PITT-04-19-008

Re: NPDES Permit No.: ESG0500015001-1 Incompleteness Review Responses Pennsylvania Pipeline Project – Mariner East 2 Goldfinch Line HDD Reroute Jackson Township, Cambria County

Comments and Responses to March 20, 2019 Incompleteness Review Letter

FOR REVIEW PURPOSES

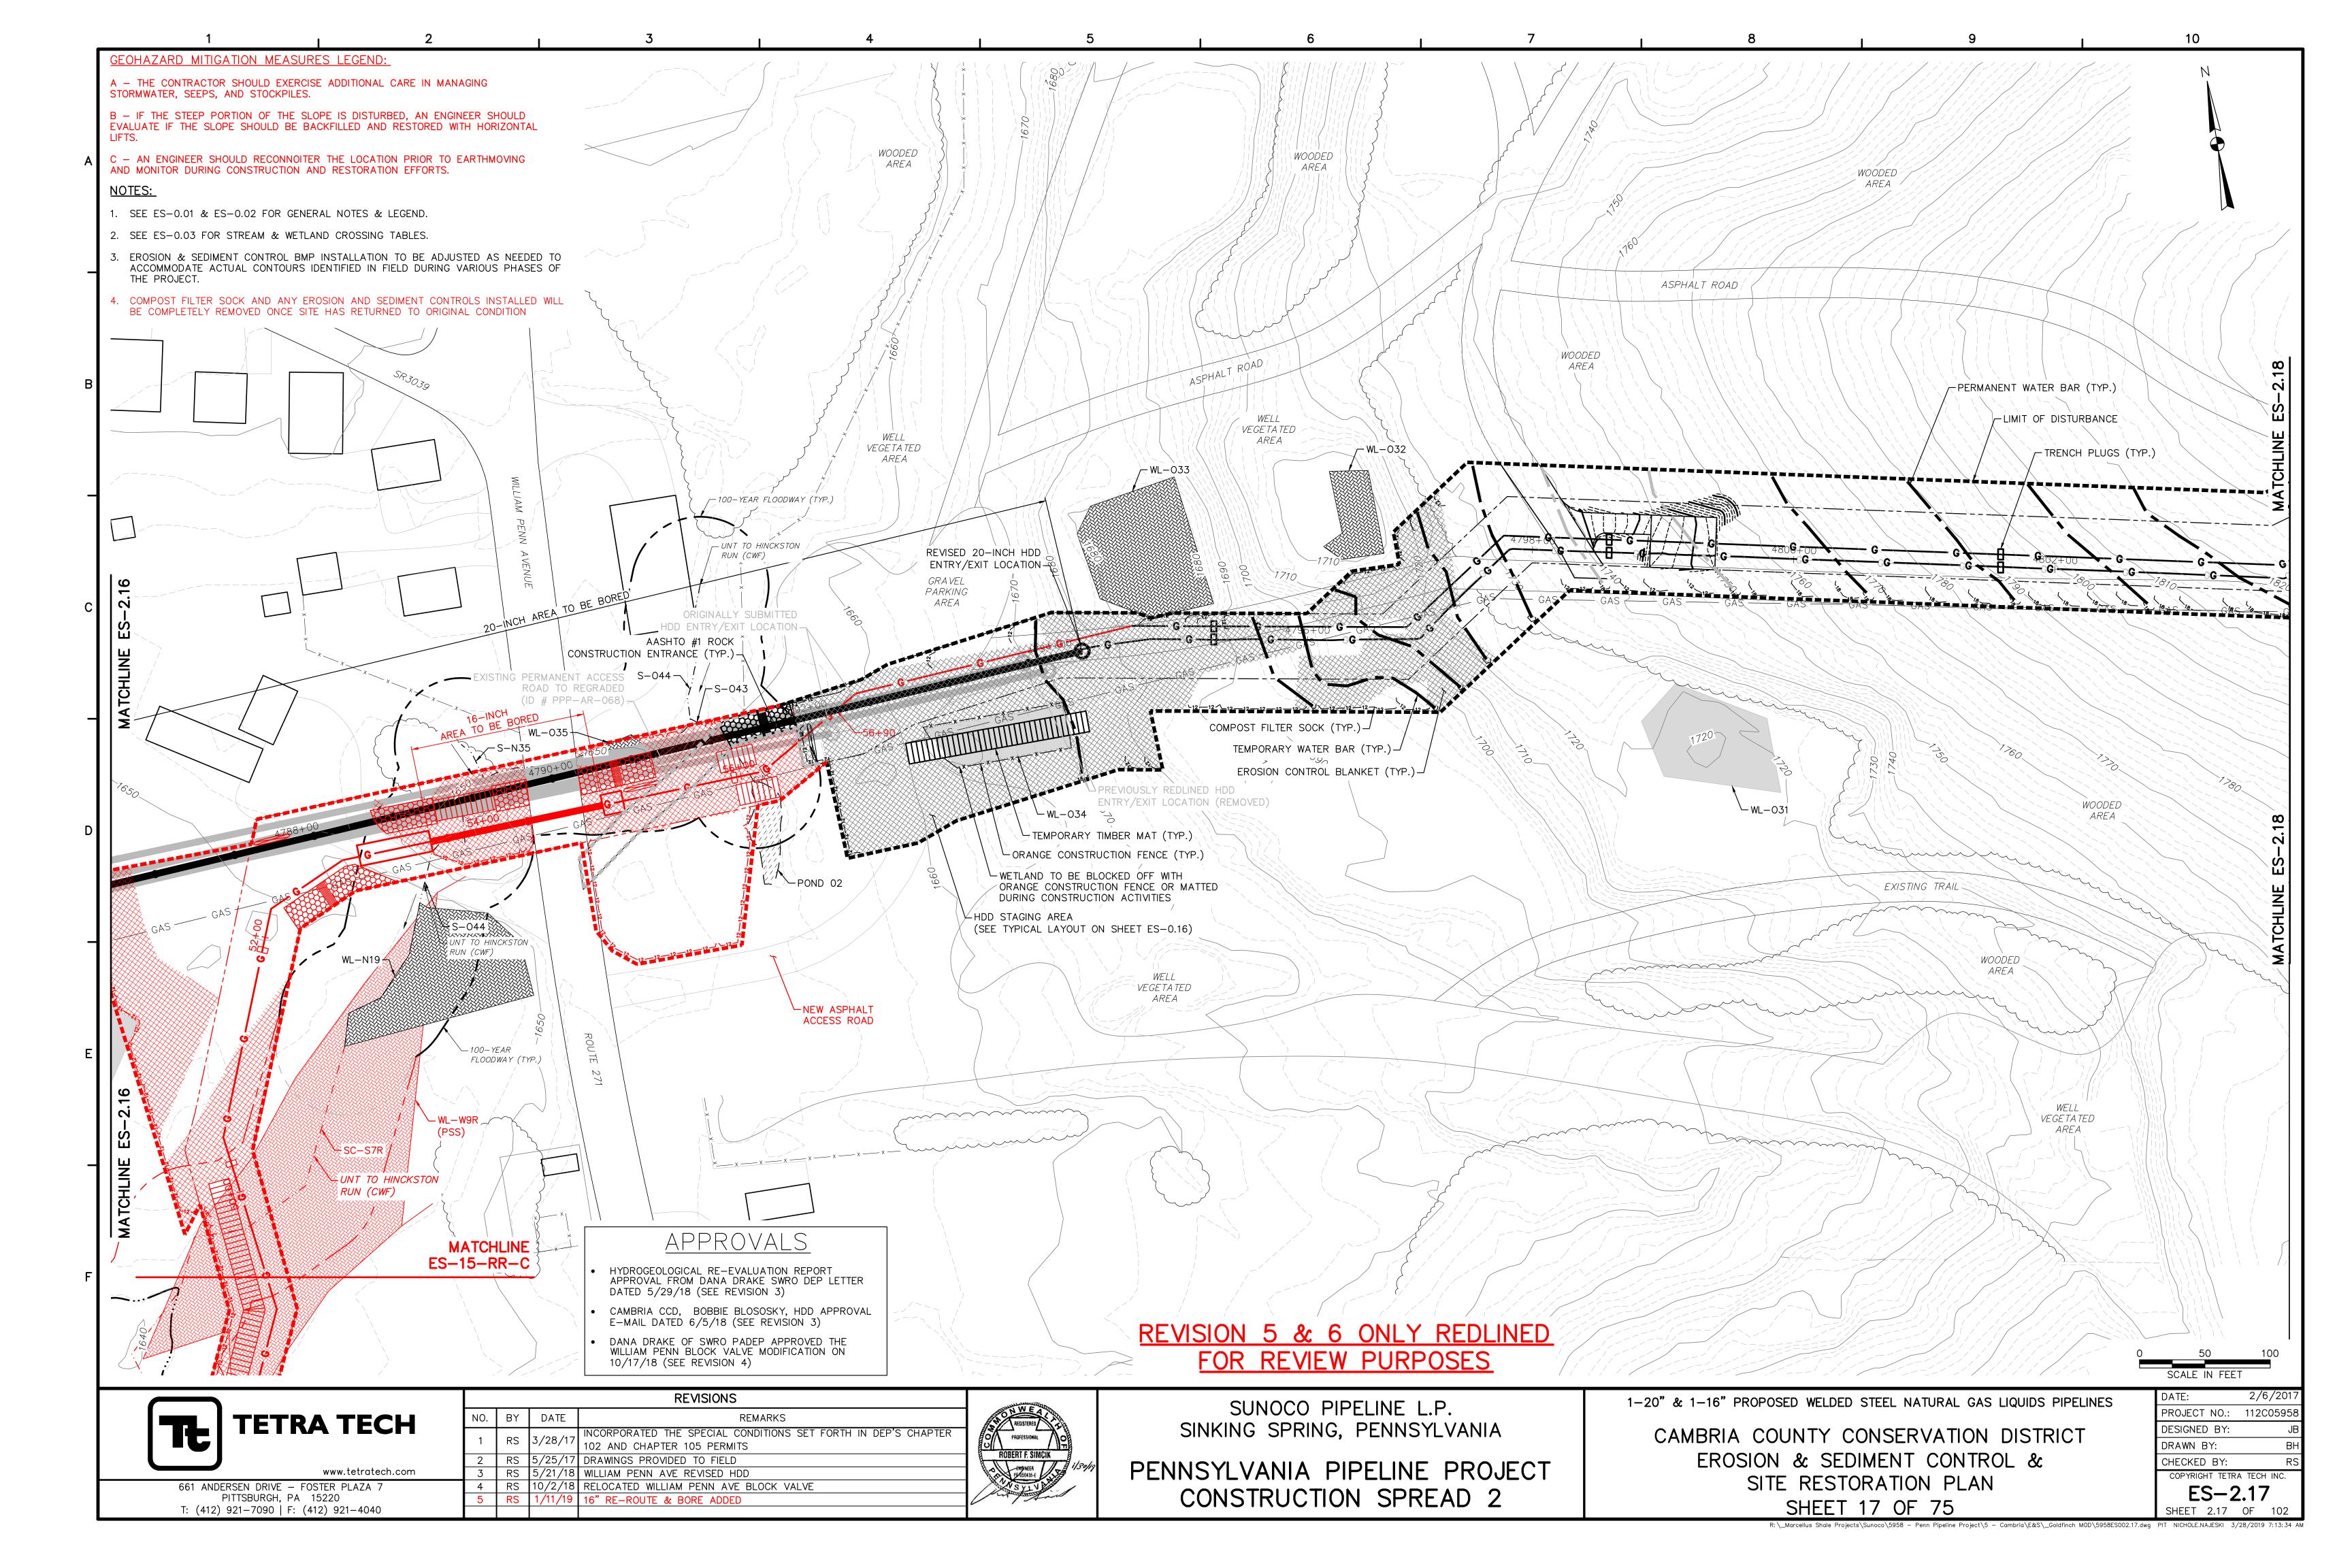
1.	102.4(b)(5)(vii): The Erosion and Sediment Plans do not discuss how and when the E&S BMPs will be removed from the wetlands. Include a note in	Attachment A of this response provides the updated plan sheets for ES-2.14, ES-15-RR-A, ES-15-RR-B, ES-15-RR-C, and ES-2.17.
ра ст е 1 Че	the E&S plans that the Compost Filter Socks will be removed once the site has been restored back to original conditions.	The figures were updated to include a note and show the proposed Compost Filter Sock within the wetlands and appropriate Erosion and Sediment control devises. Calculations to support the controls also provided.
		Maintenance and removal of erosion control devices is presented in the Narrative under Construction Sequence number 18 (pg 3-3) and applies to the wetland areas that are now included on the E&S plan sheets.

After construction and once the disturbed area tributary to the compost filter sock in the vicinity is permanently stabilized with vegetation, the diversions and level spreaders will be removed along with other erosion and sedimentation control BMPs.
